July 11, 2022

Re: 4300 Alton Road, Mount Sinai Medical Center
DRC Submittal for Design Review Board – Application No. DRB22-0845
Braman Cancer Center

Refer to sheet A015G which the generator enclosure and the setback and the requirement.

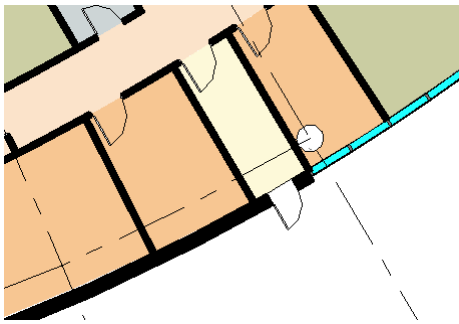
- o. Details of the generator and enclosure are required. Note the required and proposed setbacks.

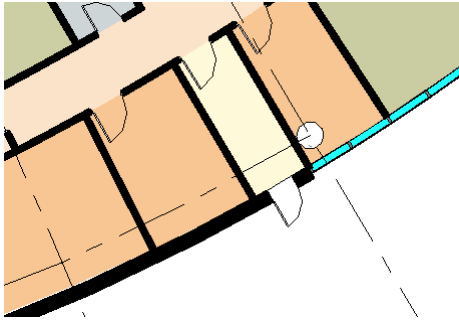
- b. A key plan must be provided on every applicable sheet, including all plans AND elevations.

Key Plans have been added, where they were missing and seem applicable.
